Hunterdon County Department of Health

August 27, 2021

Re: Septic System Waiver Request
Municipality: Clinton Township
Block: 42 Lot: 1
Location: 450 Cokesbury Road

This department has received a septic alteration design dated August 9, 2021 by Bayer-Risse Engineering for an existing 4 bedroom dwelling to a malfunctioning system with no expansion as stated on the application. The engineer proposes a Norweco Singulair Green aerobic tank to address site constraints and for greater effluent treatment. Soil logs 615-1, 615-2 and soil permeability class ratings were completed on June 15, 2021. The proposed system is a pressure dosed, soil replacement, fill enclosed installation.

**Septic System Alteration Design
 Existing & Proposed Conditions**

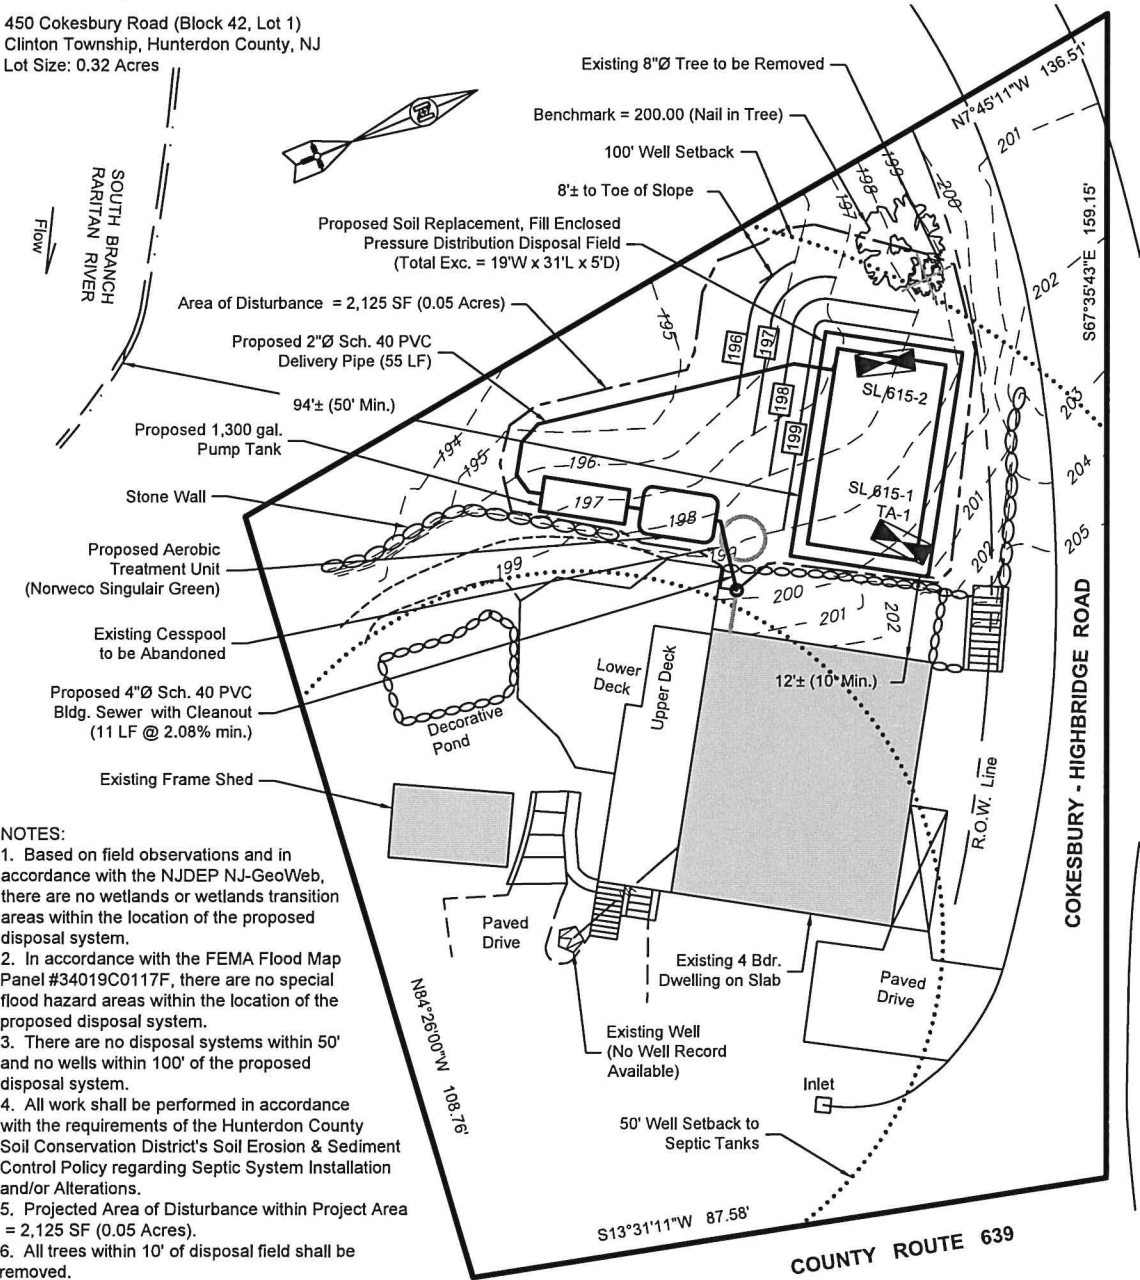
1. The existing onsite well is less than 100 feet to the proposed disposal field. The existing well is 60 feet from the proposed disposal field. The distance may be decreased by the administrative authority to a minimum of 50 feet only when the well is provided a water-tight casing to a depth of 50 feet or more. This department has no information in our archive file for the existing well. In the past the board has approved a passing water test or a UV light placed on the well if the casing is less than 50 feet. The engineer has proposed the well to be equipped with a UV light and to be maintained and kept operational for as long as the disposal system is in service. The advanced treatment is also being used to address this setback issue.

2. The proposed disposal field is less than the required 15 feet to the existing dwelling that is on a slab. The disposal field is shown 12 feet to the existing dwelling.

3. The proposed disposal field is less than the required County's policy of 10 feet from the toe of the mound to the property line. The toe of the mound is 8 feet to the property line. The engineer shall inspect the final grading and provide certification that the grading does not adversely impact off-site conditions.

4. The proposed disposal field is undersized in square footage due to space limitations. The proposed disposal field sizing is shown at 405 square feet. The minimum disposal field sizing per N.J.A.C 7:9A for a pressure dosed ATU system is 621.4 square feet.
